RECEIPT DATE: 10/4/17 **ONSITE SEWAGE DISPOSAL SYSTEM** P 561542

PROPERTY ADDRESS: 11410 Old Frederick Road

**ON SITE SEWAGE DISPOSAL SYSTEM DESIGN PLAN**  
 FOR  
**RE-BUILDING OF 11410 OLD FREDERICK ROAD**  
**MARIOTTSVILLE, MARYLAND 21104**

**RE: OSDS Plan  
11410 Old Frederick Road**

**TRENCH/DRAINFIELD DATA**

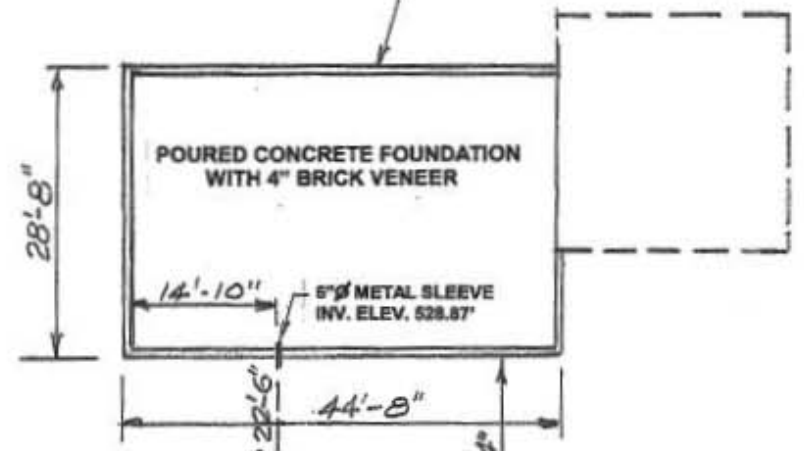
1/11/18 Met Marc Hereth on site for layout. SDA, tank, + trench staked. No laser on site - Marc says stakes are close to contour from when he last checked it. Keep tank shallower than shown on plan + move trench up in SDA prior to starting to dig trench. (S) 2/12/18 Met Marc on site. Shot contours of trench stakes and trench is level. Moved trench further into septic area to make room for tank. Trench not moved uphill at all. (S)

INSTALLATION: 2/12/18 Trench complete. 2' wide, 3.5' to stone. (SC) 2/13/18 On site while tank was set - no obvious cracks on sides or bottom. House connection made, sewer line bedded w/ #57 stone. Tank connected to trench. (S)

**WALL CHECK**

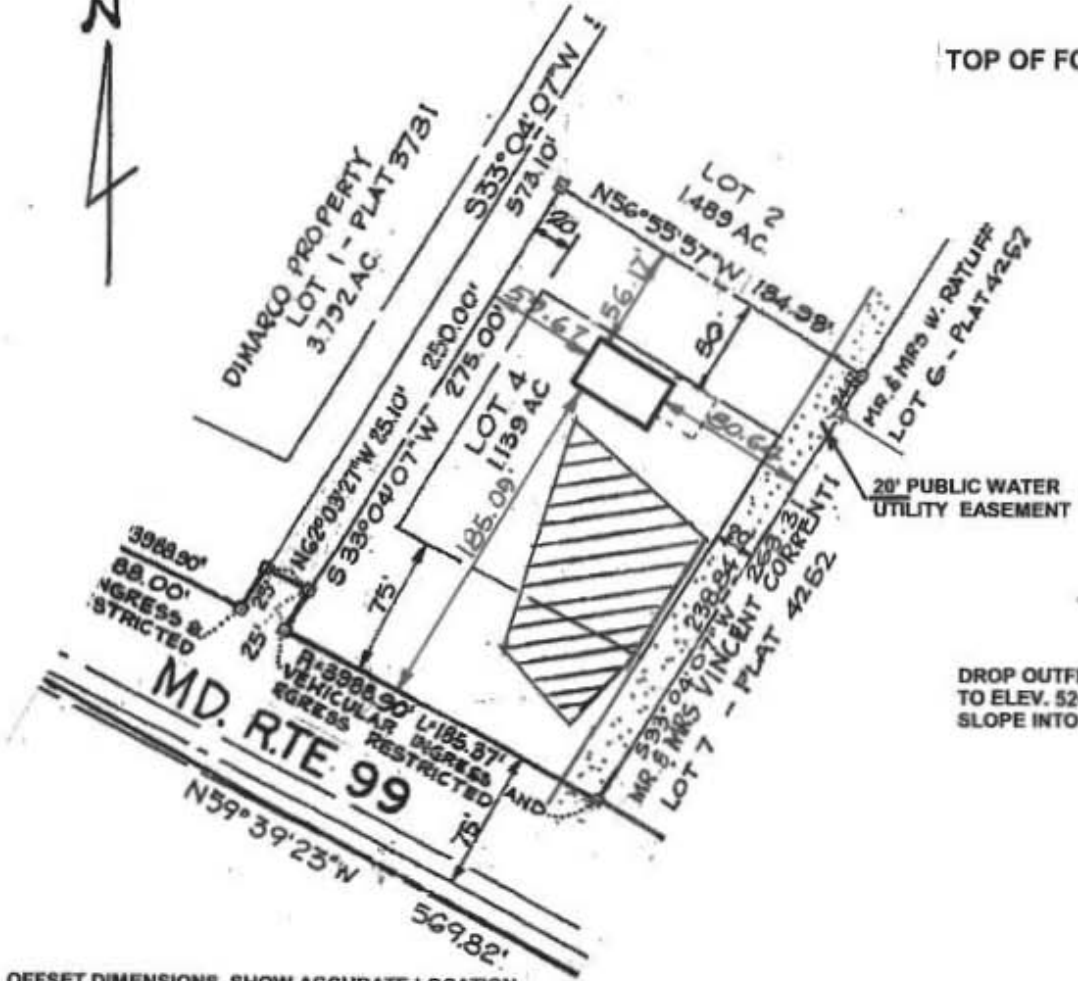
You originally requested to install the septic system prior to the house construction. We normally require a wall check to verify the foundation elevation and location prior to issuing a septic permit in order to ensure that the % fall and setbacks are acceptable and match the design plan. In order to accommodate your request, we had you sign a document stating that upon septic system completion, you would fence off the septic tank and trench area and provide the tank inlet invert elevation on the building permit plot plan prior to us approving the building permit. Upon receipt of that letter we issued the septic permit. You then requested that we issue the building permit right away instead of proceeding in the agreed upon fashion. We again accommodated you by stating that we would approve the building permit, but would not conduct the septic layout inspection unit we get a wall check similar to the standard procedure. You agreed to that requirement and we approved the building permit.

I see that the building permit has not yet been approved by two other agencies. With this circumstance, we have a limited window to again accommodate your request if we can withdraw our approval of the building permit before the other agencies approve it. Then, we can go back to the original condition of installing the septic system before we approve the building permit. If you choose to do that, please let me know as soon as possible. Be aware that the conditions you agreed to in your signed letter will again apply, which includes fencing off the tank and area and providing a field surveyed elevation of the tank inlet invert on the building permit plot plan.

DROP OUTFLOW FROM HOUSE TO ELEV. 526.56 TO ALLOW A 2% SLOPE INTO SEPTIC TANK

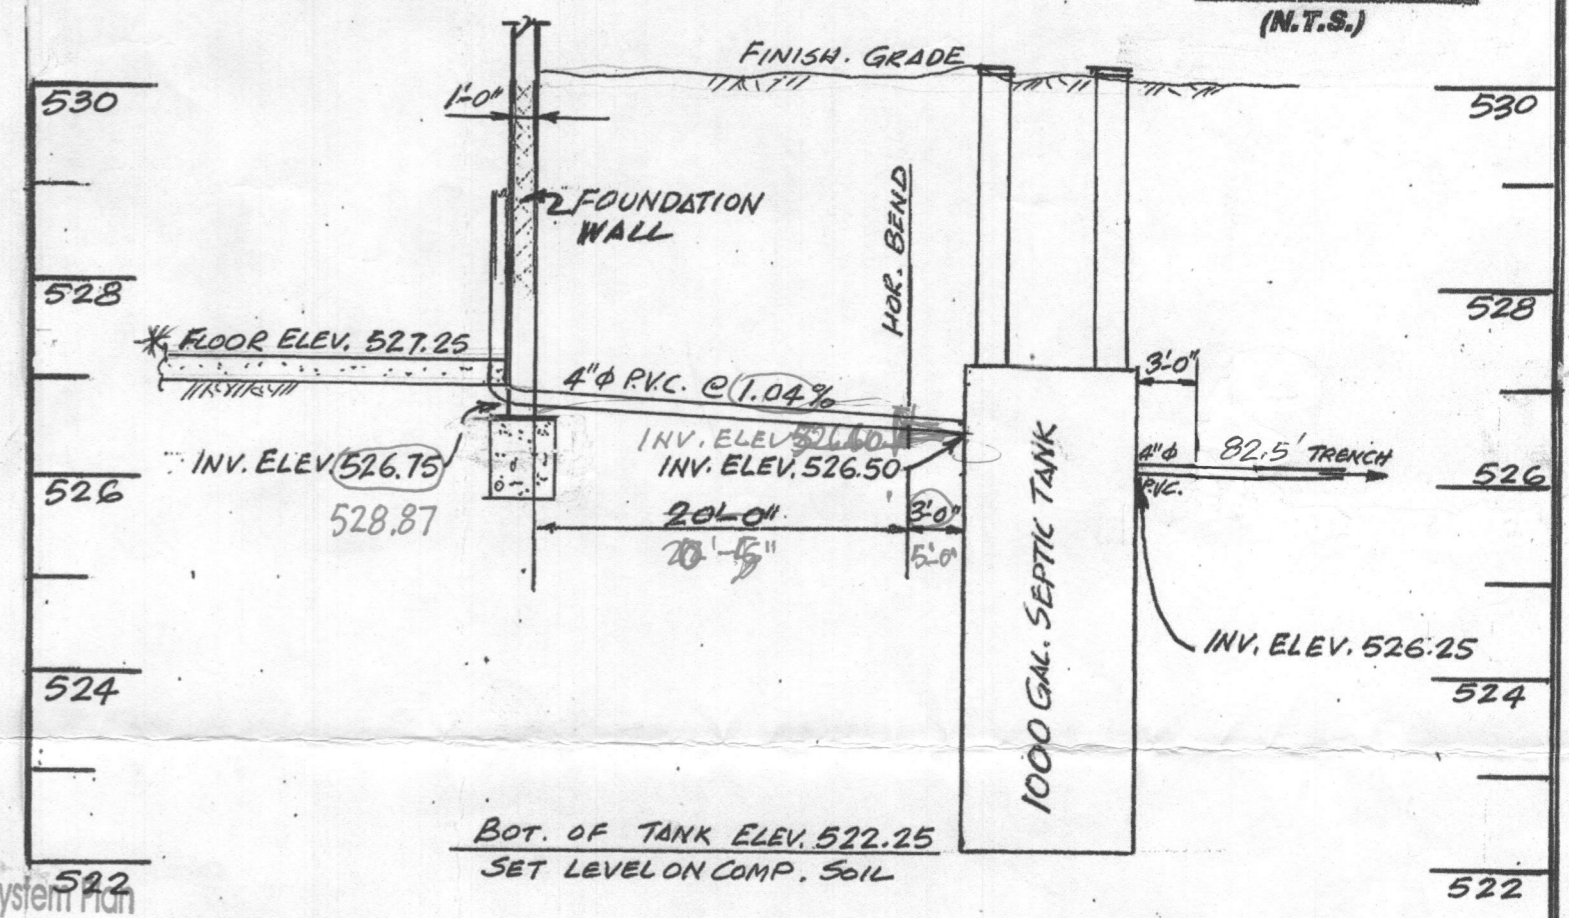
- 1.) Plan shows 25 feet of line from house to tank, while profile shows 22.5 feet. Revise to match.
- 2.) Add note, if the house elevation changes, then a revised OSDS plan will be required prior to the issuance of the septic permit.
- 3.) Show separation between d-box and first trench (at least 2 – 5 feet)
- 4.) Trench length is 82.5 feet (not 82 feet). Show actual trench length on site plan meeting setback requirement.
- 5.) Show all wells on the plan
- 6.) Add note, existing well must be properly abandoned by a licensed well driller prior to Health Department approval of the building permit.
- 7.) Submit well abandonment report(s) from your licensed well driller for the neighboring well

REVISIONS - JUNE 1, 2017 - VARIOUS HEALTH DEPT. COMMENTS
